# STERLING RECYCLING FACILITY

SECTION 5 IN TOWNSHIP 12 SOUTH RANGE 65 WEST OF THE 6TH PRINCIPAL MERIDIAN EL PASO COUNTY, CO  
SITE DEVELOPMENT PLAN

### SITE DEVELOPMENT PLAN

Please add "PCD File No. PPR-22-041" Added.

**LEGAL DESCRIPTION**

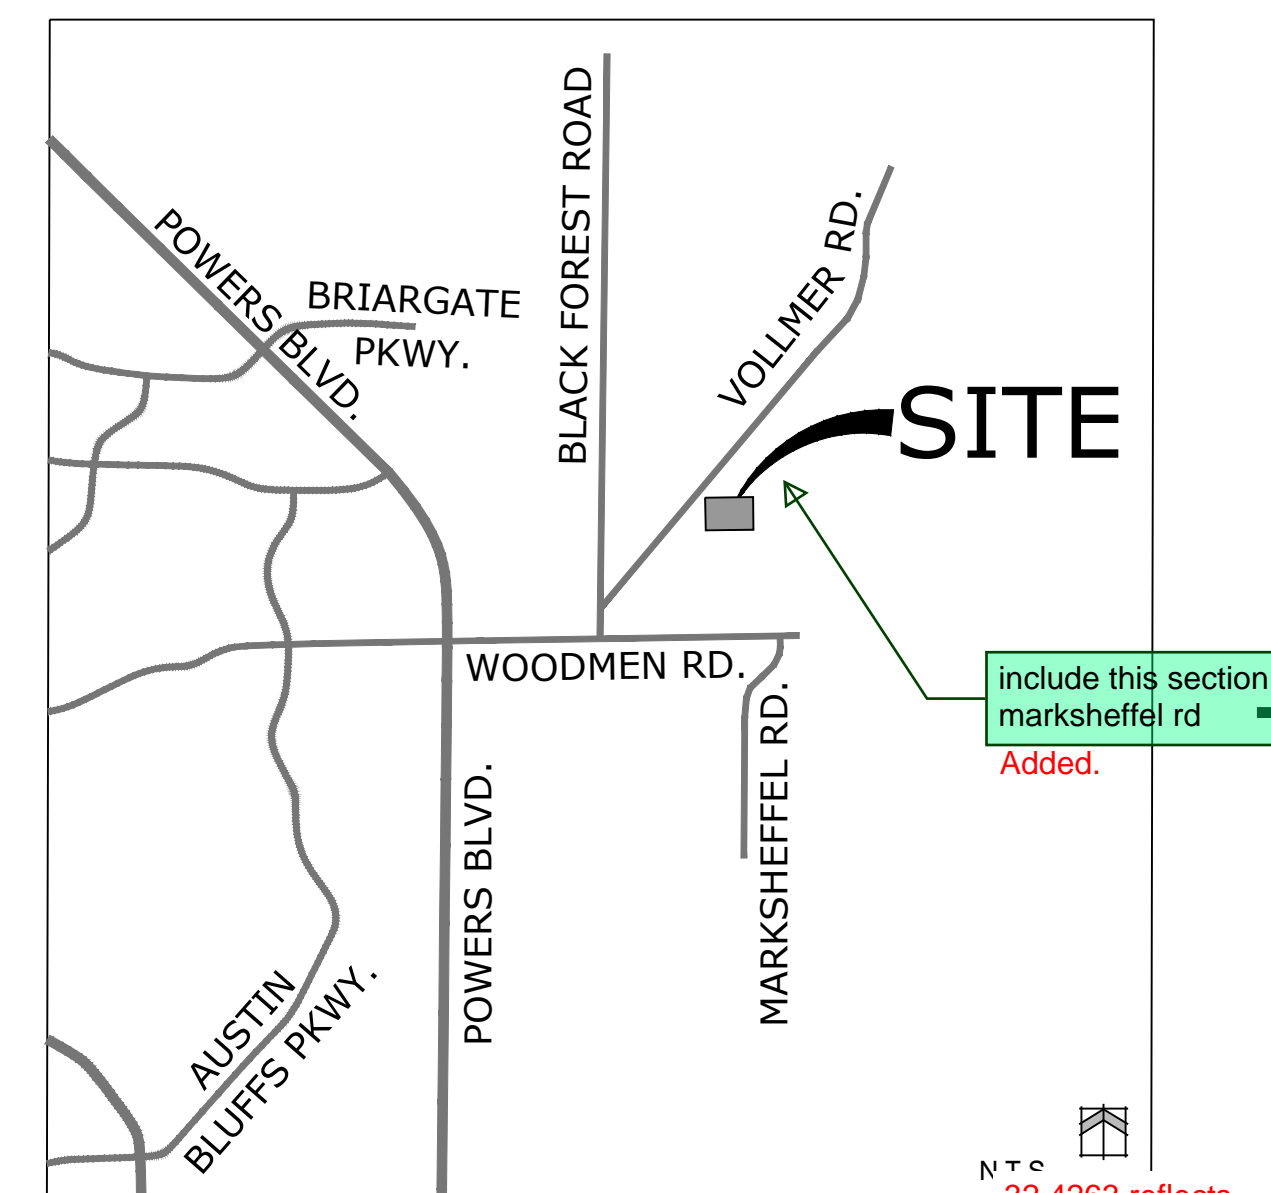
32.4263 reflects what shown on the surveyor's legal description.  
check the size - it is different (32.62 acres) in the assessor's site.

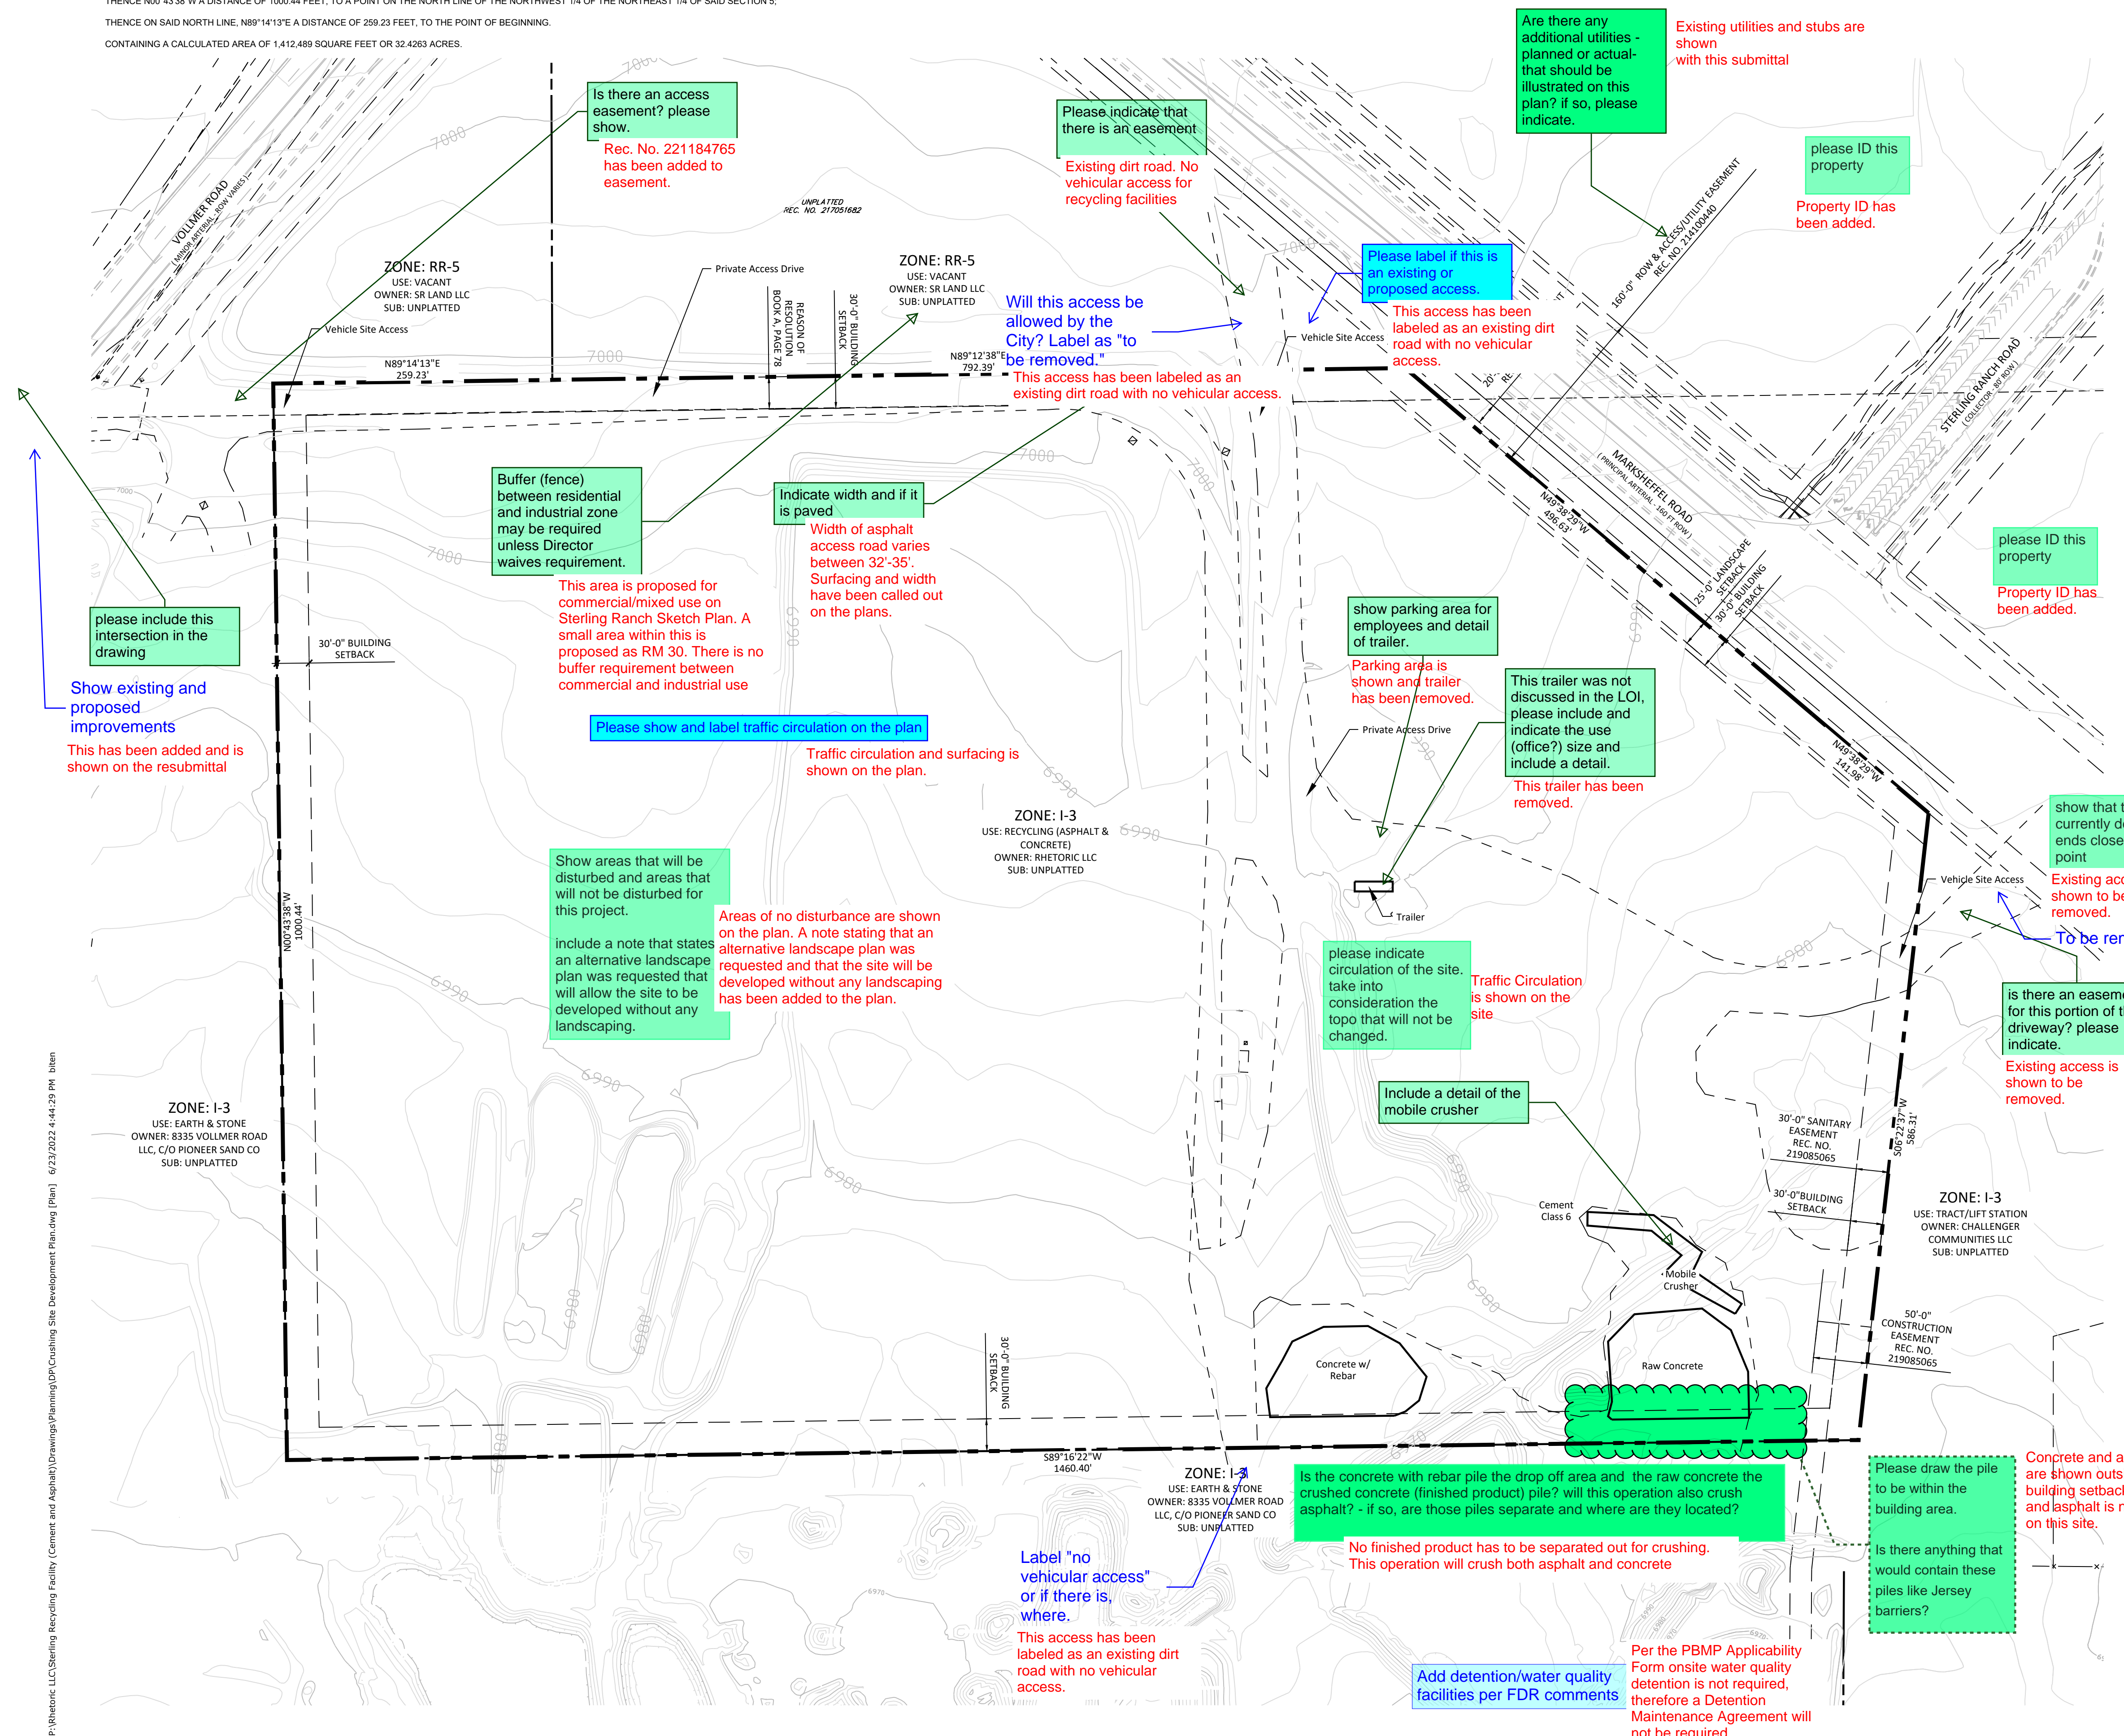
Is there an access easement? please show.  
Rec. No. 221184765 has been added to easement.

Please indicate that there is an easement  
Existing dirt road. No vehicular access for recycling facilities

Are there any additional utilities - planned or actual that should be illustrated on this plan? if so, please indicate.  
Existing utilities and stubs are shown with this submittal

please ID this property  
Property ID has been added.

Please label if this is an existing or proposed access.  
This access has been labeled as an existing dirt road with no vehicular access.

Will this access be allowed by the City? Label as "to be removed."  
This access has been labeled as an existing dirt road with no vehicular access.

Buffer (fence) between residential and industrial zone may be required unless Director waives requirement.  
This area is proposed for commercial/mixed use on Sterling Ranch Sketch Plan. A small area within this is proposed as RM 30. There is no buffer requirement between commercial and industrial use

Indicate width and if it is paved  
Width of asphalt access road varies between 32'-35'. Surfacing and width have been called out on the plans.

show parking area for employees and detail of trailer.  
Parking area is shown and trailer has been removed.

This trailer was not discussed in the LOI, please include and indicate the use (office?) size and include a detail.  
This trailer has been removed.

Please show and label traffic circulation on the plan  
Traffic circulation and surfacing is shown on the plan.

Show areas that will be disturbed and areas that will not be disturbed for this project.  
include a note that states an alternative landscape plan was requested that will allow the site to be developed without any landscaping.  
Areas of no disturbance are shown on the plan. A note stating that an alternative landscape plan was requested and that the site will be developed without any landscaping has been added to the plan.

please indicate circulation of the site, take into consideration the topo that will not be changed.  
Traffic Circulation is shown on the site

show that this road currently dead ends close to this point  
Existing access is shown to be removed.  
To be removed?

is there an easement for this portion of the driveway? please indicate.  
Existing access is shown to be removed.

Include a detail of the mobile crusher

Please draw the pile to be within the building area.  
Concrete and asphalt piles are shown outside of the building setbacks. Concrete and asphalt is not stock piled on this site.  
Is there anything that would contain these piles like Jersey barriers?

Is the concrete with rebar pile the drop off area and the raw concrete the crushed concrete (finished product) pile? will this operation also crush asphalt? - if so, are those piles separate and where are they located?  
No finished product has to be separated out for crushing. This operation will crush both asphalt and concrete

Label "no vehicular access" or if there is, where.  
This access has been labeled as an existing dirt road with no vehicular access.

Add detention/water quality facilities per FDR comments

Per the PBMP Applicability Form onsite water quality detention is not required, therefore a Detention Maintenance Agreement will not be required.
